Title: TTCN CRs cat. B to TS 34.123-3 v.3.5.1, v.3.5.2, v.3.6.0 and v.3.6.1

Agenda item: 5.1.3

This document contains the category B CRs to TTCN part of TS 34.123-3 v.3.5.1, v.3.5.2, v.3.6.0 and v.3.6.1. These CRs have been agreed by T1 and are put forward to TSG T for approval.

4.19 cr_ RP_DATA_02 (WA#SMS1092)

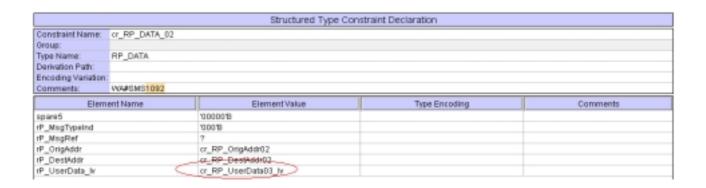
Reason for change A comment from Sasken which claimed that short messages to be

Summary of change To hold a maximum length SM submitted by the UE and caught with

4.4.5 ts_CPHY_TGCFN_250_252_254

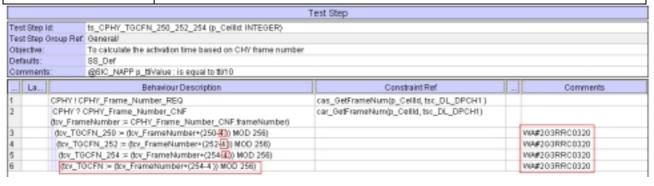
TTCN object	ts_CPHY_TGCFN_250_252_254
Reference ATS	IR_U_wk23.mp [3]
Change Label	WA#2G3RRC0320
Reason for change	1) tti value 20ms is wrong 2) TS 34.123-1 specifies that the TGPS reconfiguration CFN in Measurement Control Message should be set to (Current CFN + (250 – TTI/10msec)) mod 256. But TTCN tcv_TGPRFCN is set to '0' and used in the measurement control message.
	Note: See change 1 in Anite's_additional_modifications_to_8_4_1_35-MCC160comments.doc [7].
Summary of change	1) tti value is set to 40ms. 2) tcv_TGPRFCN is updated as per the calculation given in specs inside the test step ts_CPHY_TGCFN_250_252_254. 3) The updated tcv_TGPSRFCN is passed as parameter for Measurement control message and local end configuration.
Other affected objects	
ETSI comment	
R&S conclusion

4.3.1 cr_MeasReportInterRatMeas1

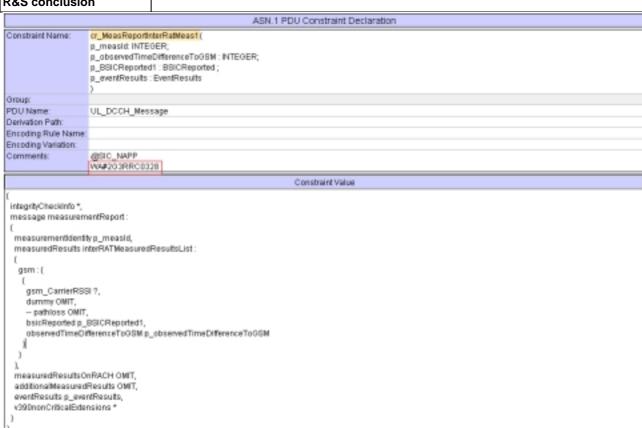
TTCN object	cr_MeasReportInterRatMeas1
Reference ATS	IR_U_wk23.mp [2]
Change Label	WA#2G3RRC0328
Reason for change	In TC 8.4.1.36, cr_MeasReportInterRatMeas is used to receive a measurement report containing two measured results. Alternatively, the UE may send a measurement report containing only one measured result. A new constraint is required for this purpose.
Summary of change	Introduce new constraint cr_MeasReportInterRatMeas1 similar to cr_MeasReportInterRatMeas but containing only one measured result.
Other affected objects	tc_8_4_1_36
ETSI comment	
R&S conclusion

4.2 ts_RB_SendRB_SetUp_DCH_8k_8k_PS (WA#RAB4362)

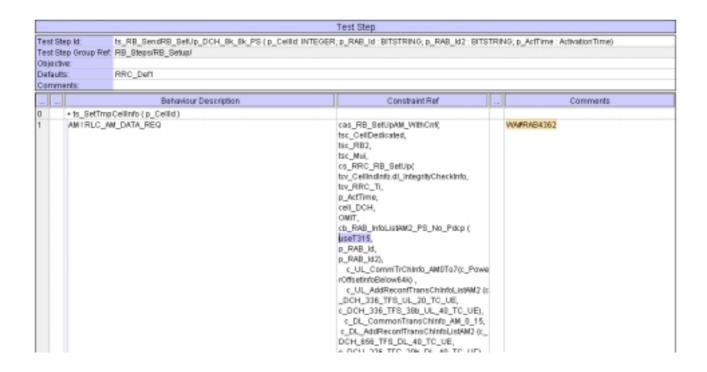
Reason for change Wrong "Establishment Timer" for a PS configuration. T315 should be used

instead of T314.

4.5 Change 4

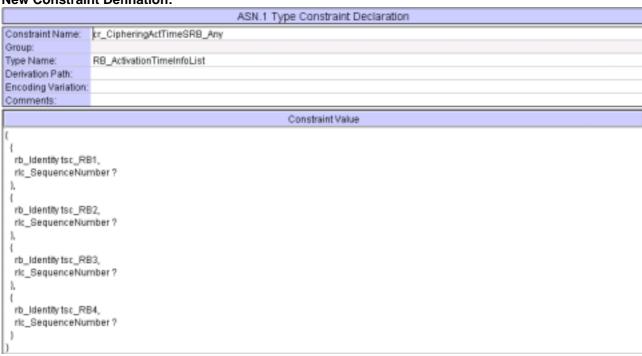
Local Tree and Test step	TC_8_1_7_1
Reason for change	 In Step 9 of test case 8_1_7_1 the received security mode complete message is checked for the ciphering activation time for RB20. This is a CS mode test and RB20 is not present.
Summary of change	 New constraint "cr_CipheringActTimeSRB_Any" is defined which does not check the ciphering activation time for RB20. This new constraint is used in step 9 of TC_8_1_7_1
Source of change	New change
